SUNDRY NOTICES AND REPORTS ON WELLS
Do not use this form for proposals to drill or to re-enter an abandoned well. Use form 3160-3 (APD) for such proposals.

8. Well Name and No.
FRIESS FEDERAL 4

Fries Federal #4 – Eddy County, NM
Plug and Abandonment Proposed Procedure

NM Schematic

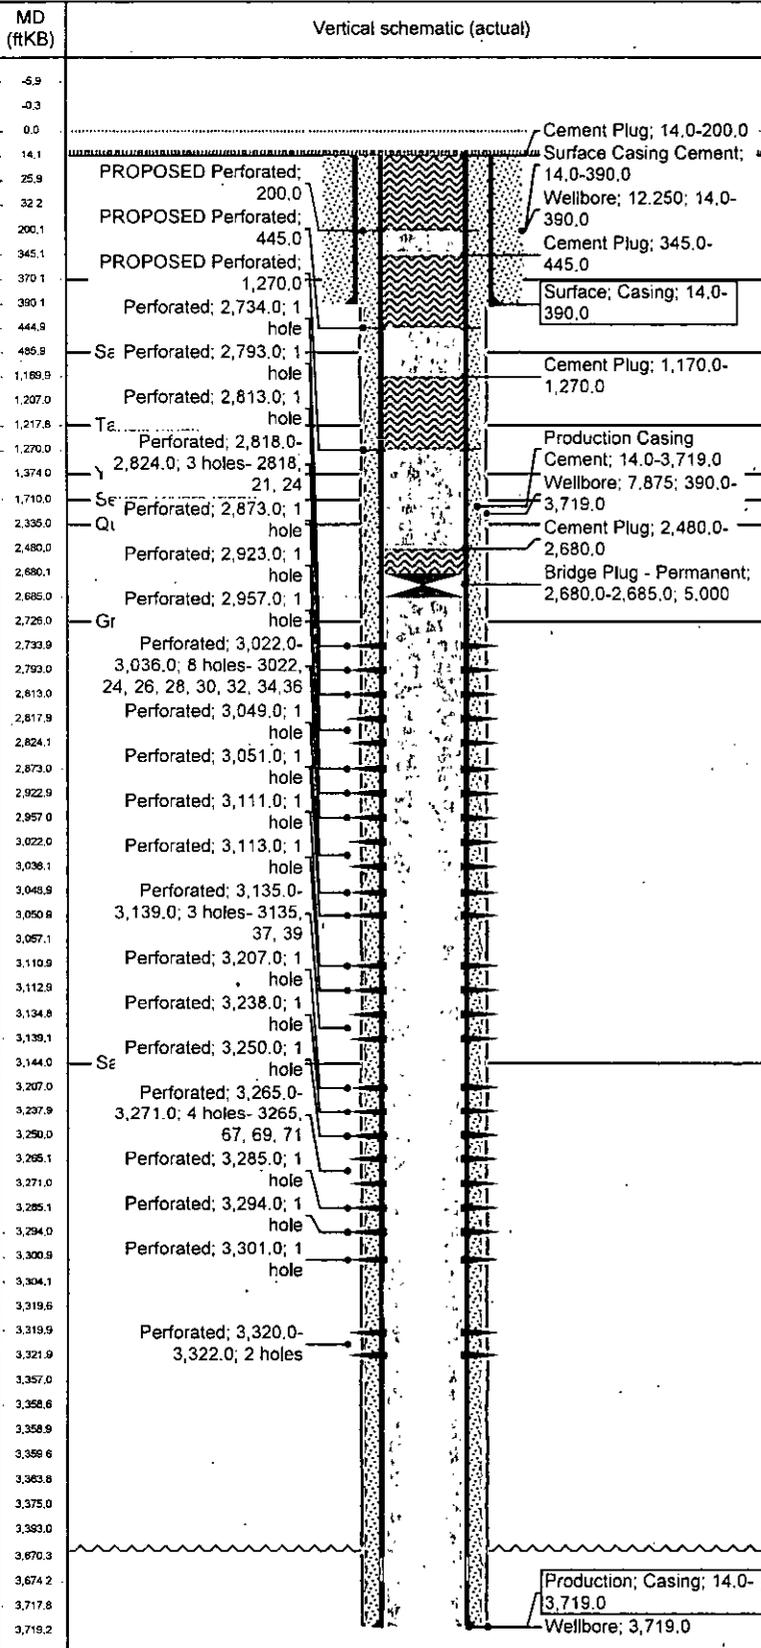
See Changes

Below ground level dry hole marker required

1. Set 5-1/2" CIBP @ 2680'. Circulate hole with mud laden fluid
2. Spot 25 sx cement @ 2680' – 2480'
3. Perf & sqz 25 sx @ ~~1270~~ ~~111~~ 700. WOC and tag. 1400 sqz ent to 1300
4. Perf & sqz 25 sx @ ~~445~~ ~~345~~. WOC & tag. 536 – 340
5. Perf & sqz 45 sx @ 200' – surface.
6. Cut off wellhead and weld on below ground dry hole marker.
